Low-Slope Roofing Quality Assurance Inspection Report

Project # PR2003

Membrane Type: 2 ply SBS Soprema

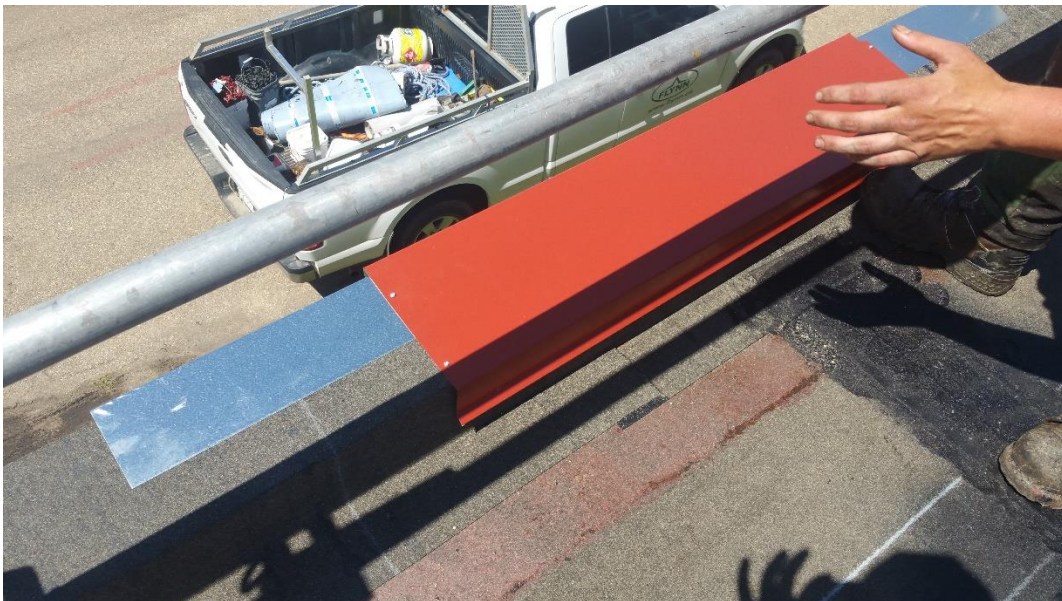
Item:	Roof Observations:	Action by:
5.01	<p>The contractor is mainly working on getting section D stripped in and put back together. With two other crew members torching cap sheet on the other side of the building.</p> 	info
5.02	<p>Thailer Insulated plumbing vent as per spec.</p> 	Info
